CORPS OF ENGINEERS

2-1-50	CORRECTED DWG. NO. — ADDENDUM NO. 2
REVISION	DATE
DESCRIPTION	
CORPS OF ENGINEERS U. S. ARMY OFFICE OF THE DISTRICT ENGINEER HUNTINGTON, W. VA.	
DRAWN BY: E.S.W.	TUSCARAWAS RIVER LOCAL PROTECTION PROJECT MASSILLON, OHIO SIPPO CREEK PUMP STATION LOCATION PLAN & PROFILES
TRACED BY: L.L.L.	
CHECKED BY: M.W.W.	
APPROVED BY: J. E. Johnson	
DATE: DEC. 1949	DATE: DEC. 1949
SCALE: AS SHOWN	SPEC. NO.
DRAWING NUMBER 0271-PM-51.3/1	SHEET 25 OF 42

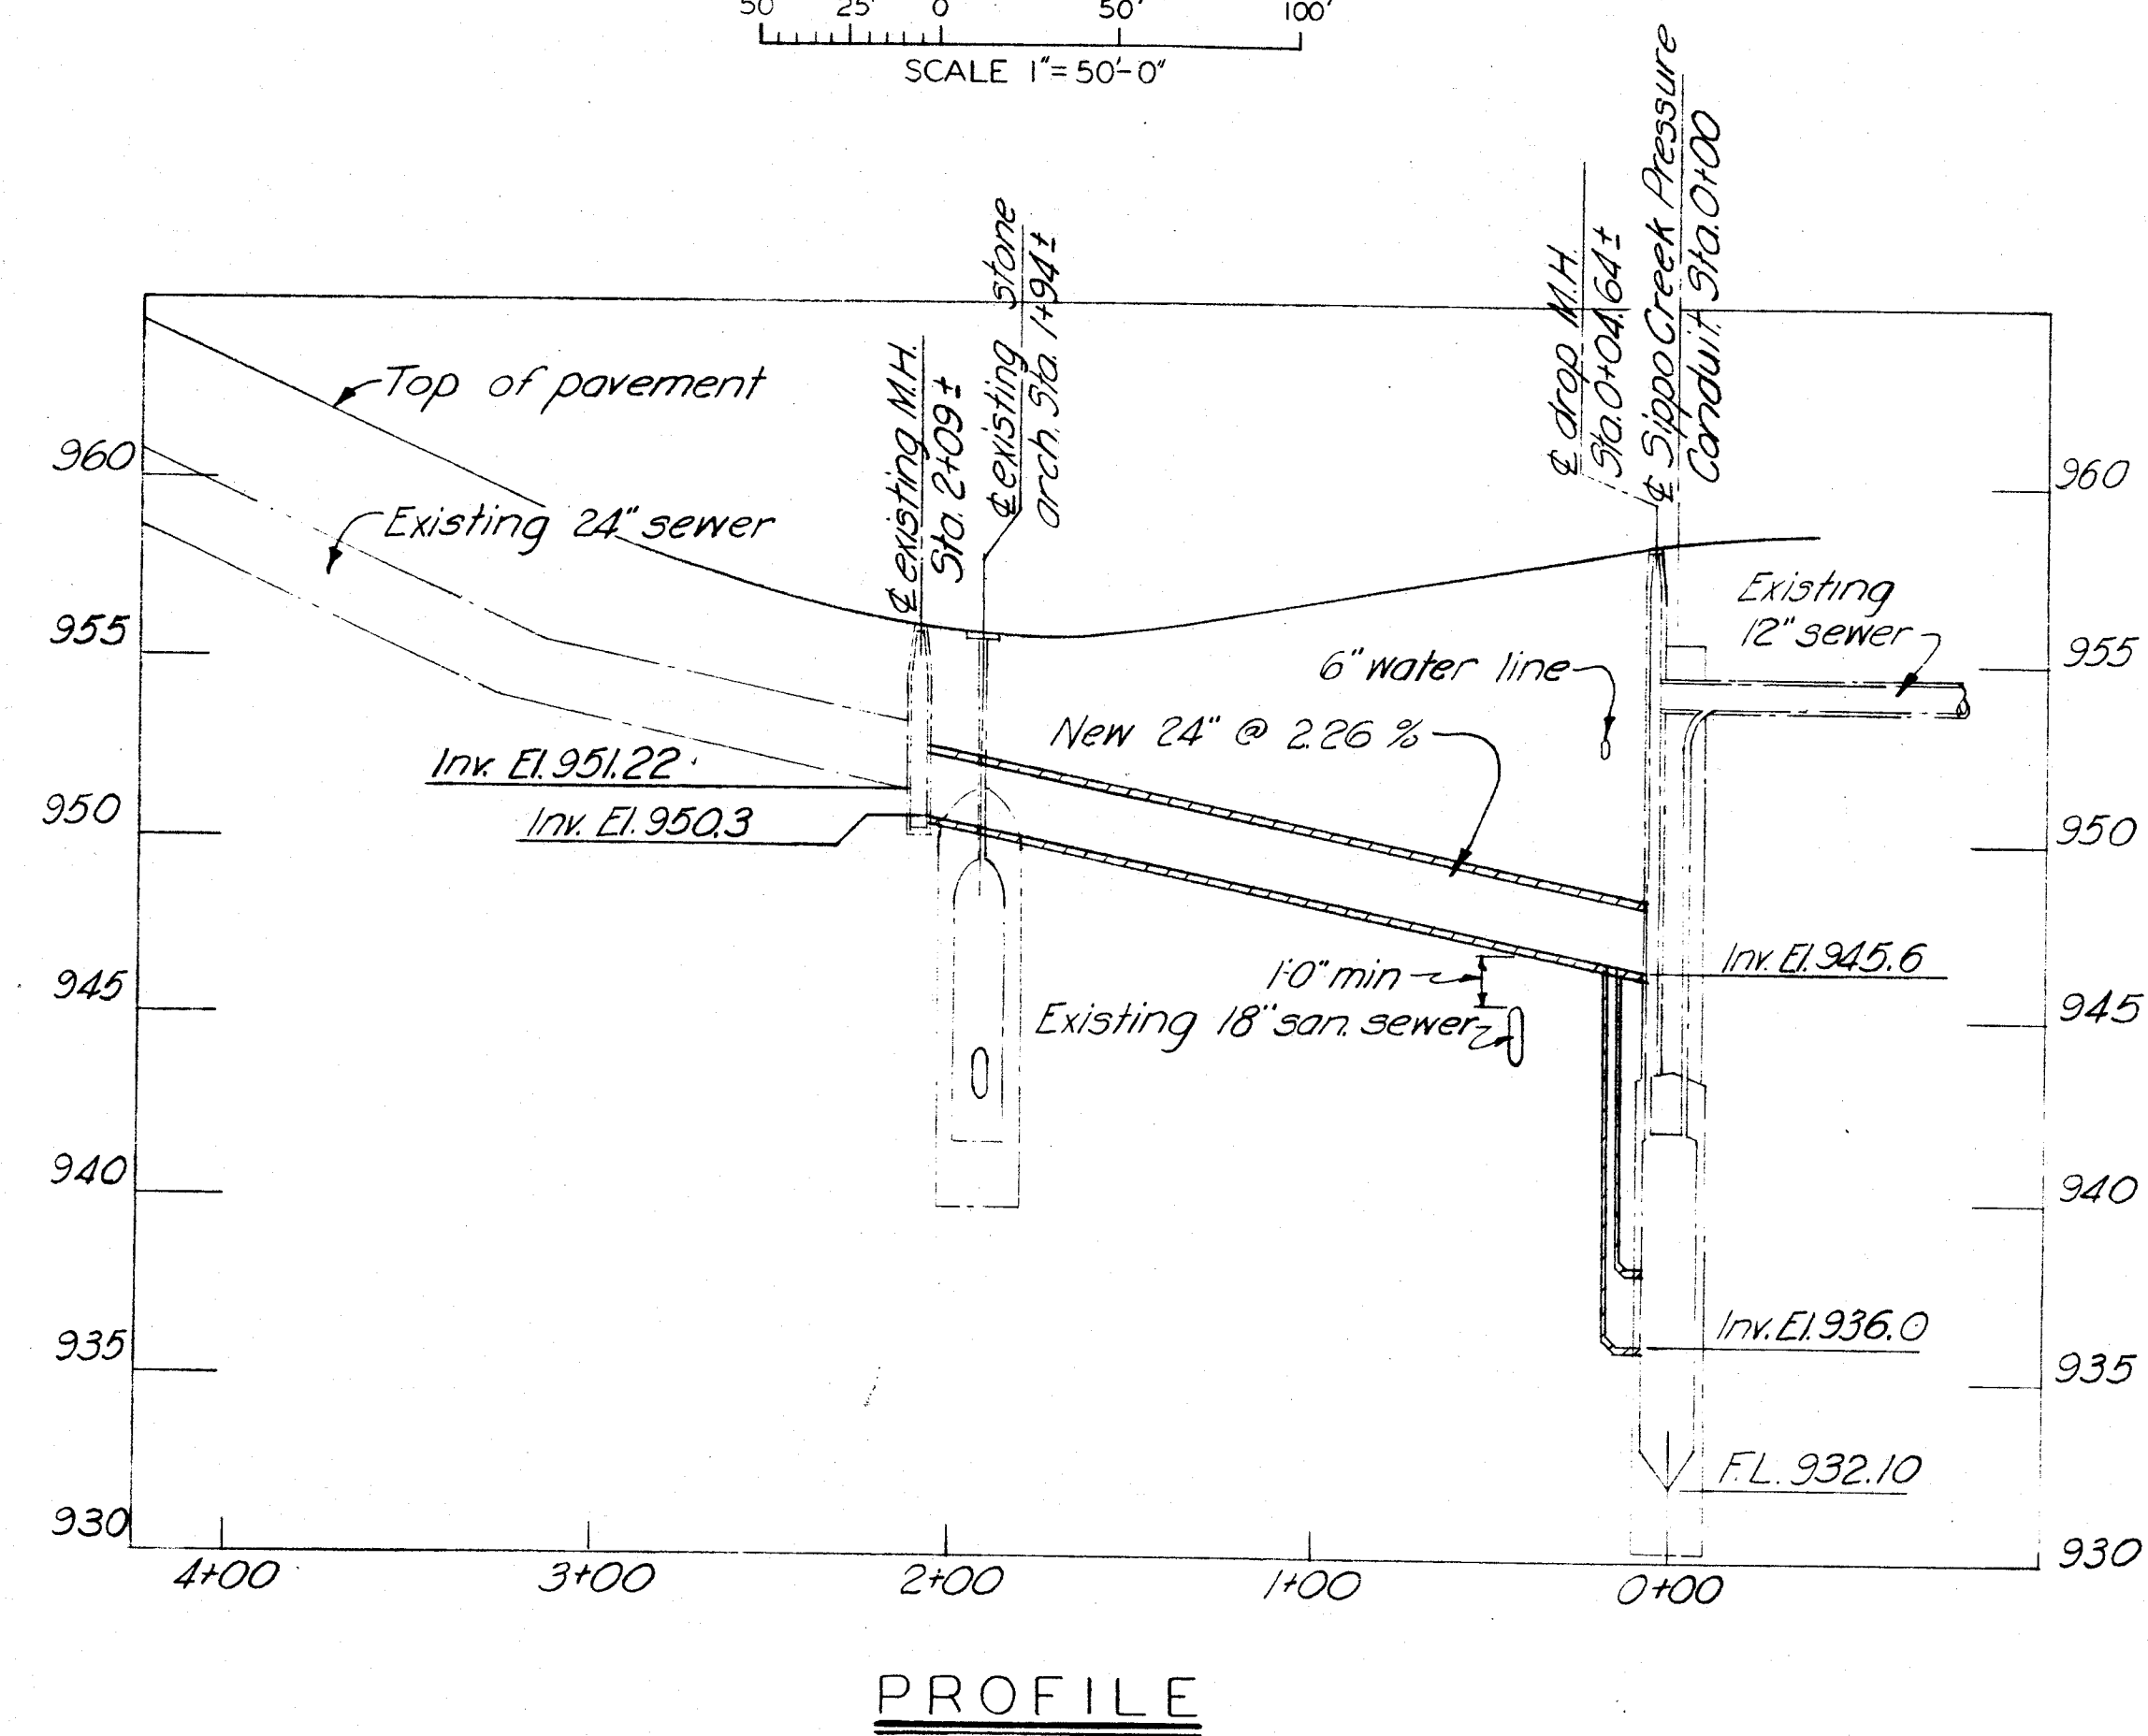
2-1-50	ADDED ELEVATIONS OF TOP OF GROUND AND INVERT OF SEWER - ADDENDUM NO. 1	K.S.B.
REVISION DATE	DESCRIPTION	BY
CORPS OF ENGINEERS U. S. ARMY OFFICE OF THE DISTRICT ENGINEER HUNTINGTON, W. VA.		
TUSCARAWAS RIVER LOCAL PROTECTION PROJECT MASSILLON, OHIO SIPPO CREEK PUMP STATION ALTERATIONS		
DRAWN BY: E.W.H.-L.L.L.	DATE: DEC. 1949	
TRACED BY: L.L.L.	SPEC. NO.	
CHECKED BY: M.D.-M.W.W.	DRAWING NUMBER -513/9

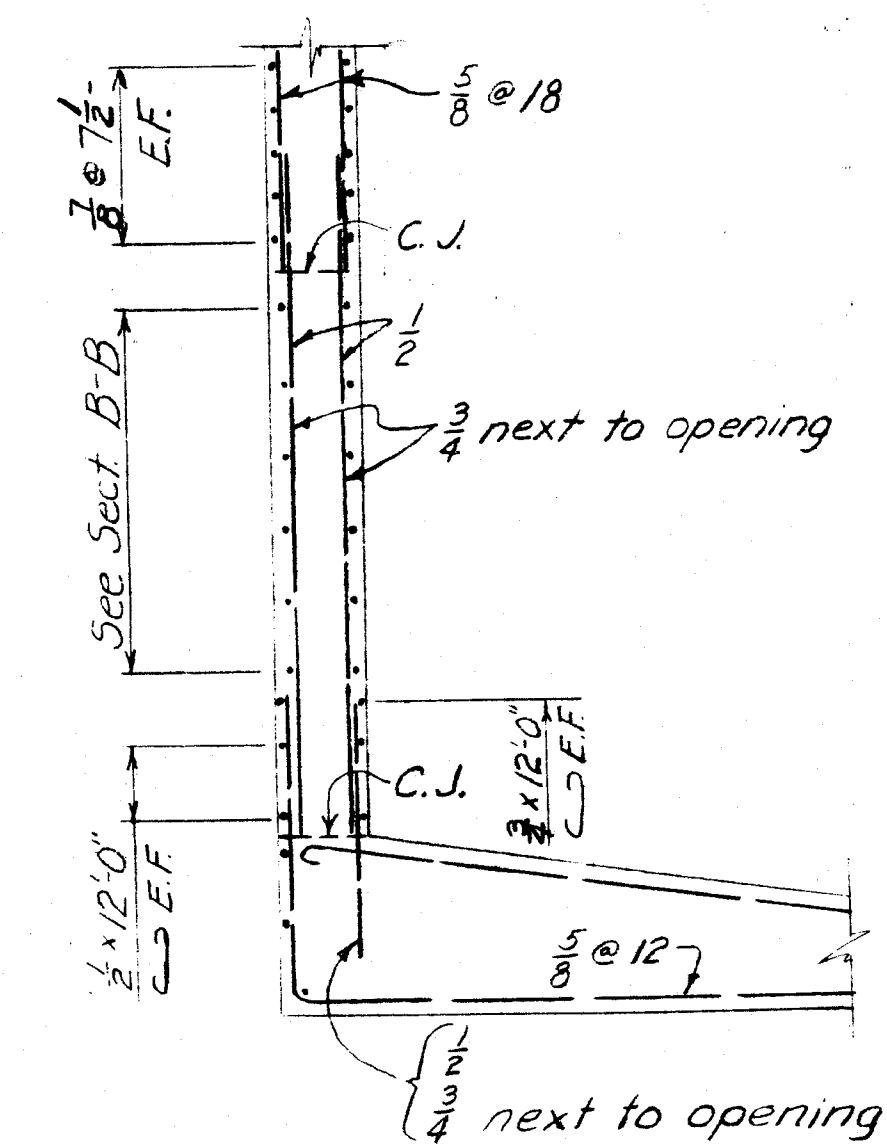
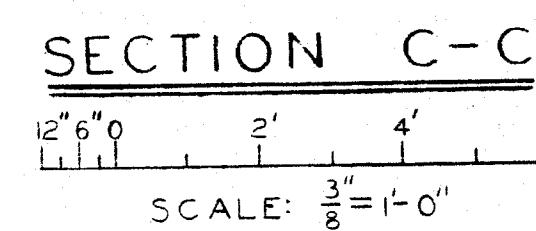
2-1-50		ADDED NOTE AND TITLED SLUICE GATE WELL-ADDENDUM NO.2		X 5	
REVISION		DATE		DESCRIPTION	
				BY	
CORPS OF ENGINEERS U. S. ARMY OFFICE OF THE DISTRICT ENGINEER HUNTINGTON, W. VA.					
DRAWN BY: E.S.W.		TUSCARAWAS RIVER LOCAL PROTECTION PROJECT MASSILLON, OHIO SIPPO CREEK PUMP STATION REINFORCING DETAILS			
FRACED BY: F.W.L.					
CHECKED BY: H.D.G.-M.W.W.					
SUPERINTENDING ENGINEER <i>[Signature]</i>					
APPROVED BY: <i>[Signature]</i>					
APPROVED:		<i>D. Johnson</i>		DATE: DEC. 1949	
COL. C. E. DISTRICT ENGINEER		SCALE: $\frac{3}{8}'' = 1'-0''$		SPEC. NO.	
DRAWING NUMBER		0271-PM-51.3/6			
DATE:		SHEET 28 OF 42
